Clover Hill DDI Interchange and Roundabout Thoughts

Bottom Line Up Front

FIGURE 3-23 DOUBLE LEFT TURN LANES

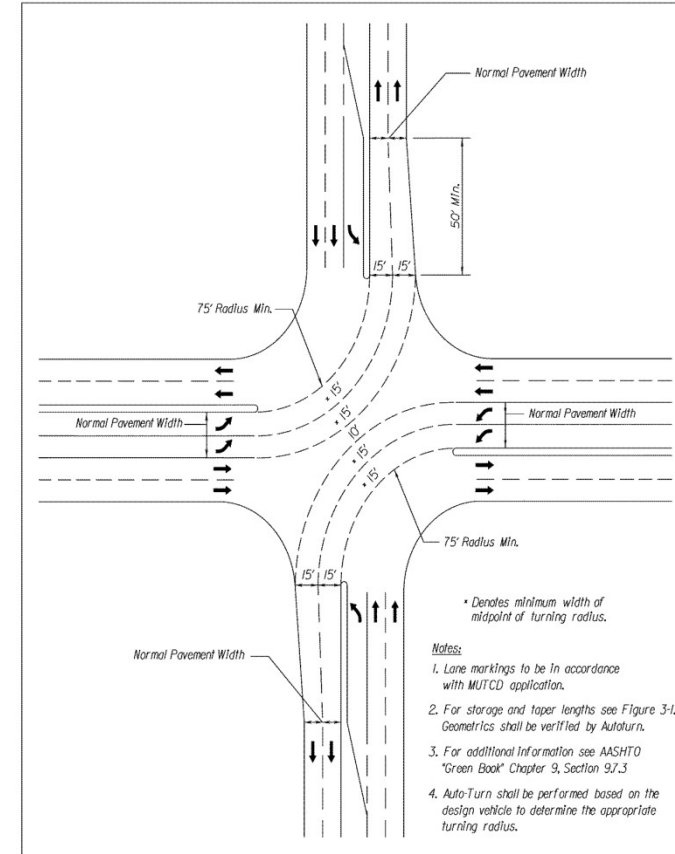
- 15' lanes are above normal lane design spec but justified by project personnel referencing VDOT design standard for 15' approaches on DDI. VDOT design standard in question is found on page A3-40 of the VDOT RDM and references Figure 3-23 in Appendix F (depicted here).
- The Balls Ford Road DDI uses 12' bridge lanes.

Lane Width Continued

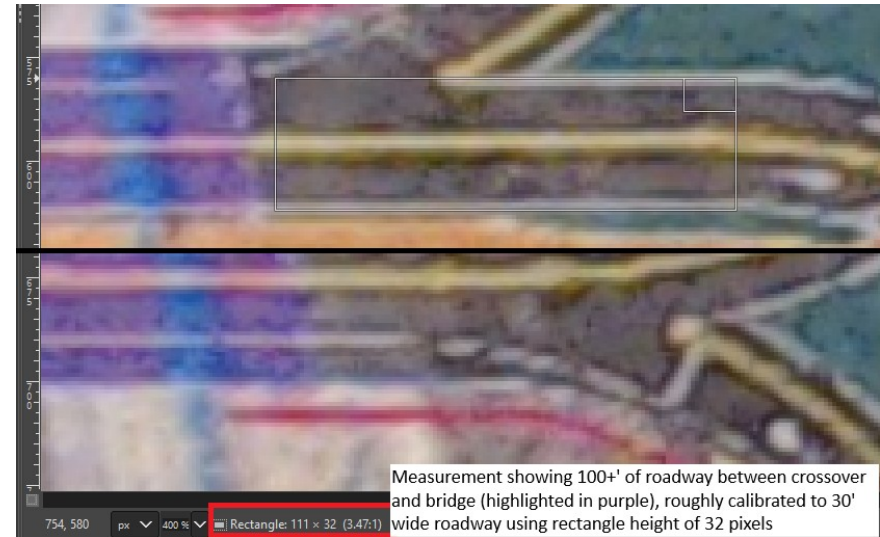
- There is roughly 100' between the crossovers in the drawings and the start of the bridge, well above the 50' minimum taper length recommended by the RDM.

Design Consideration 3: 234 SUP

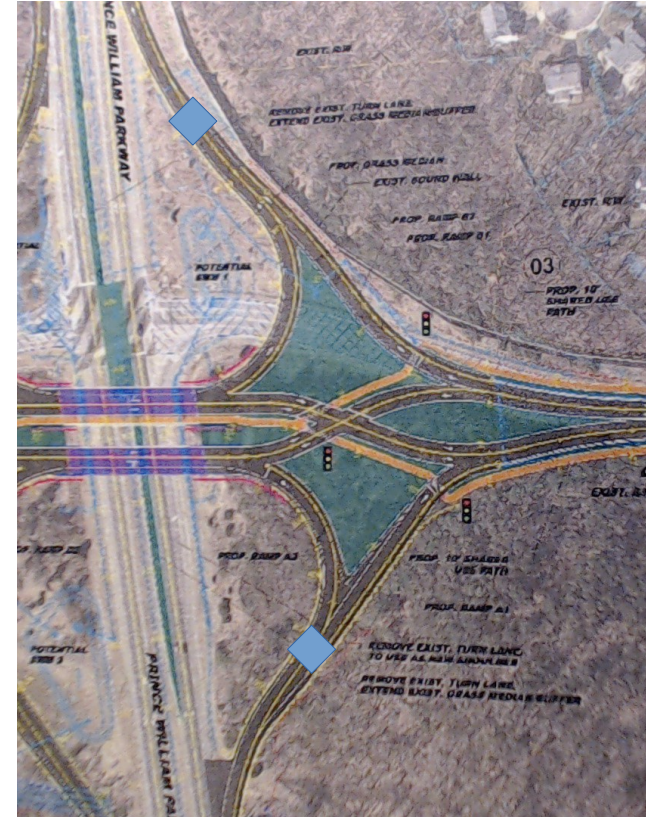
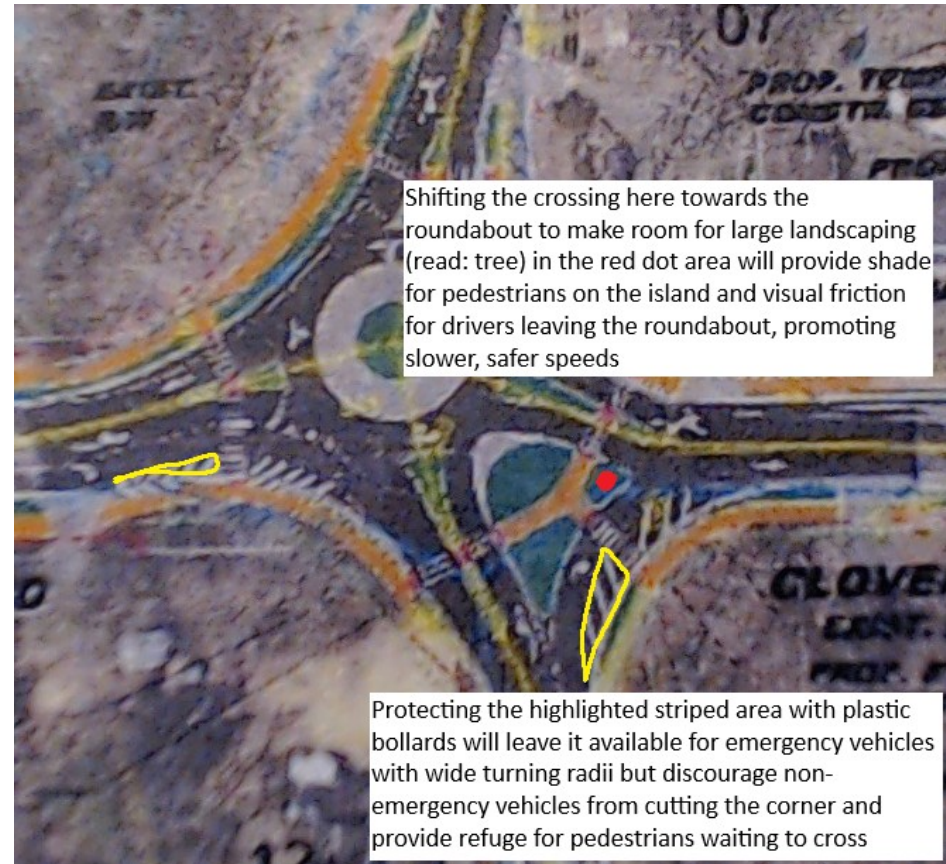
- Providing connections between the outside of the interchange and the space allocated under the bridge for the 234 SUP will be easiest/most cost effective/least disruptive while the new highway ramps are being constructed.
- Recommend installing a box culvert under the east-side ramps during earthworks/grading to provide an easy connection for future path construction efforts

Blue boxes represent possible box culvert sites to provide connectivity to the underpass before doing so would disrupt traffic and cost big bucks
